ADDENDUM NO. 2
September 27, 2023

PROJECT: CITY OF ROPESVILLE
DWSRF WATER TREATMENT PLANT

CITY OF ROPESVILLE		DWSRF WATER TREATMENT PLANT		ELECTRICAL FLOOR PLAN	
SCALE	1/8"=1'	PROJECT #	19119	DESIGNED	ERW
DATE	09/26/2023	DRAWN	CC	CHECKED	ERW
NO.	REVISION	ADDENDUM #2	BAR IS ONE INCH IN LENGTH ON ORIGINAL DRAWING. CHECK SCALE & ADJUST ACCORDINGLY.		
SHEET		E-2			
SEQ.		31 OF 33

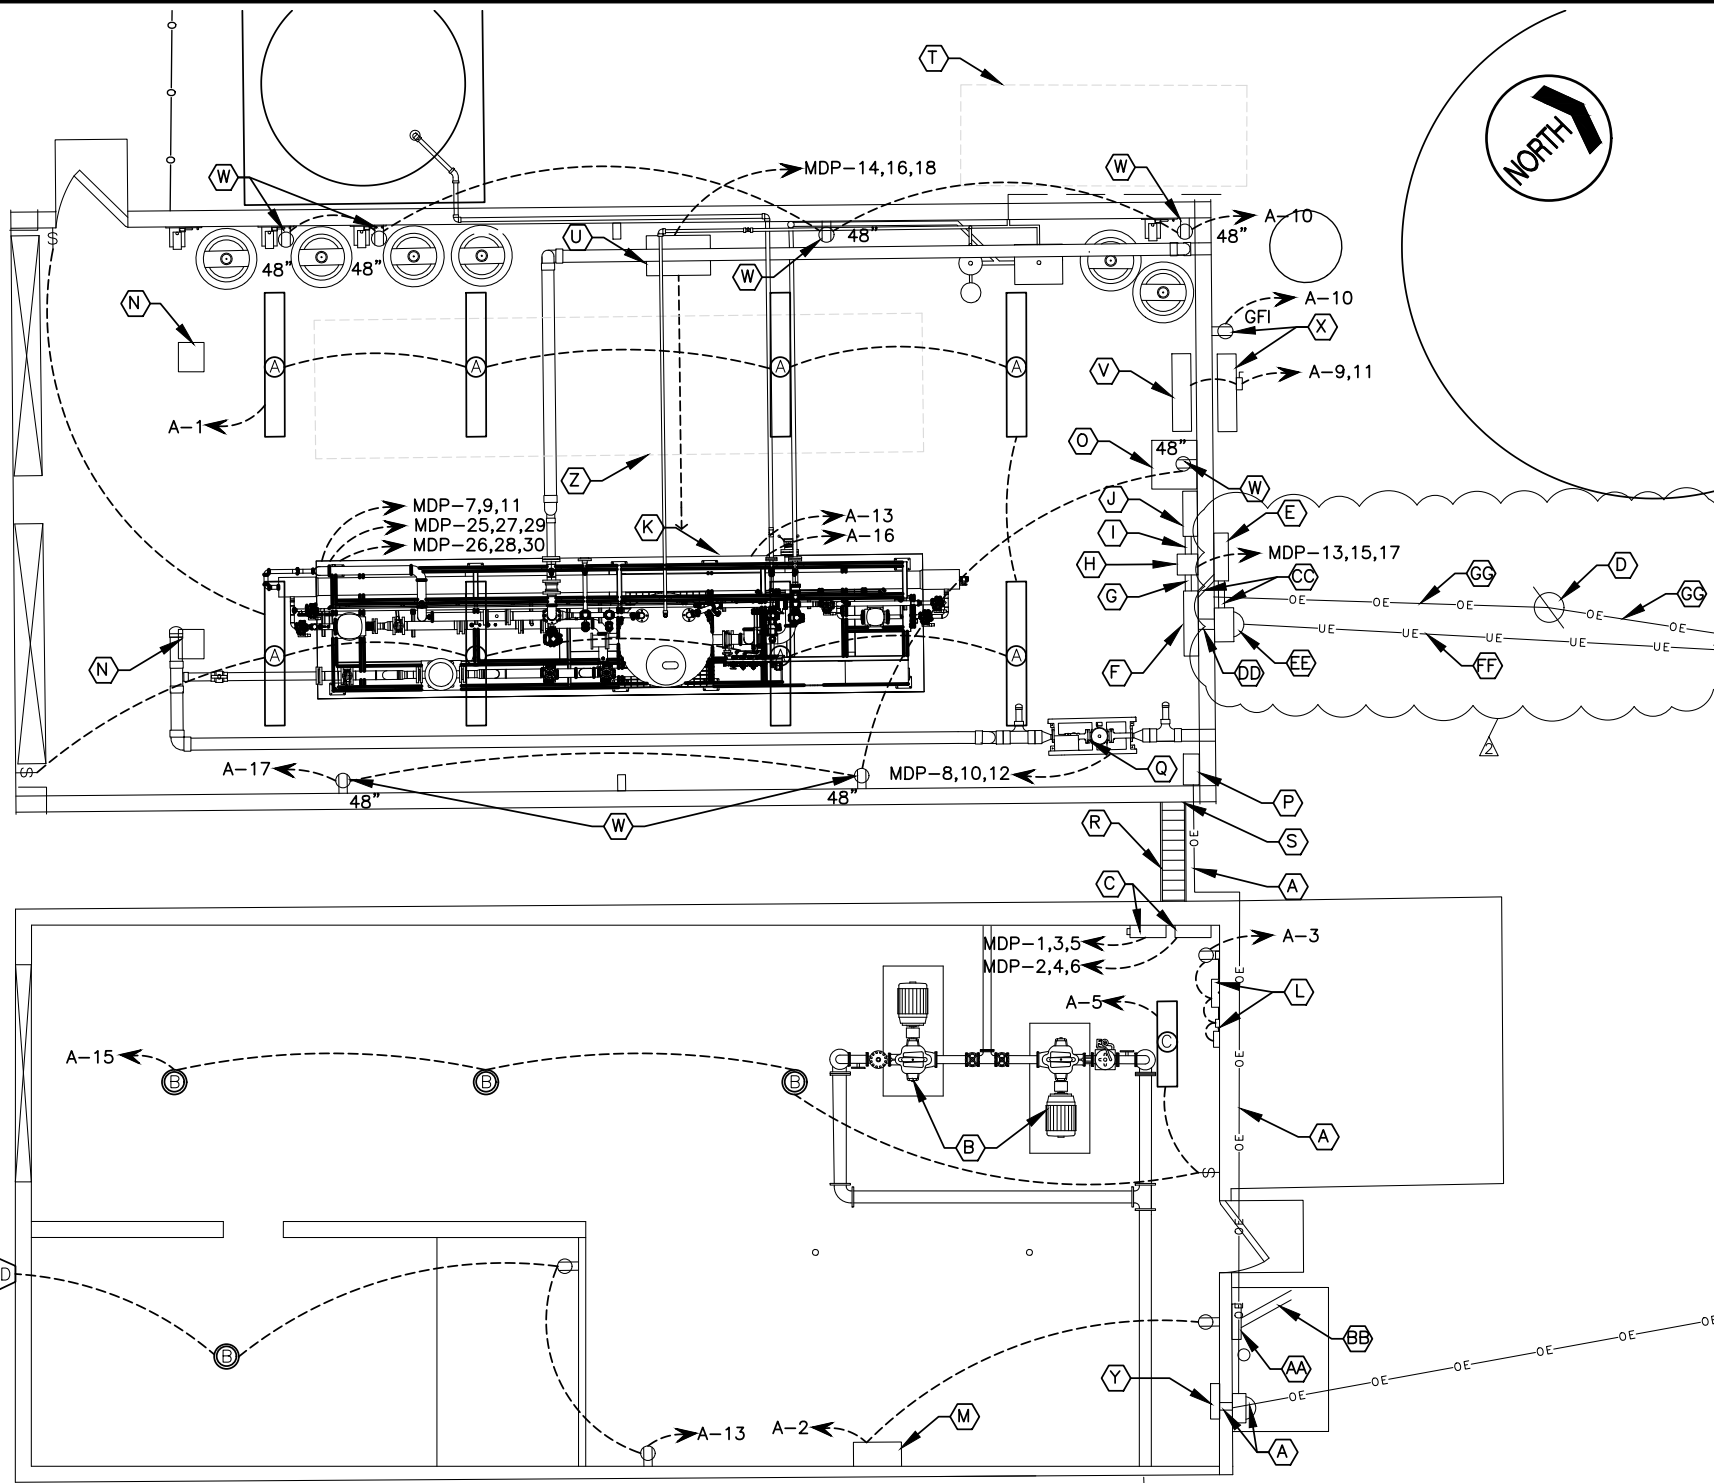
E1-E3 – Electrical Site Plan, Floor Plan and Riser Diagram have been modified to show underground secondary to building. Please see all attached electrical sheets.

(FF) NEW XCEL 480V, 3Ø UNDERGROUND ELECTRICAL SECONDARY. REFERENCE ELECTRICAL SITE PLAN SHEET 30 FOR FULL CONDUIT ROUTE AND MORE DETAILS.
(GG) EXISTING XCEL OVERHEAD ELECTRICAL SECONDARY TO BE REMOVED BY XCEL.
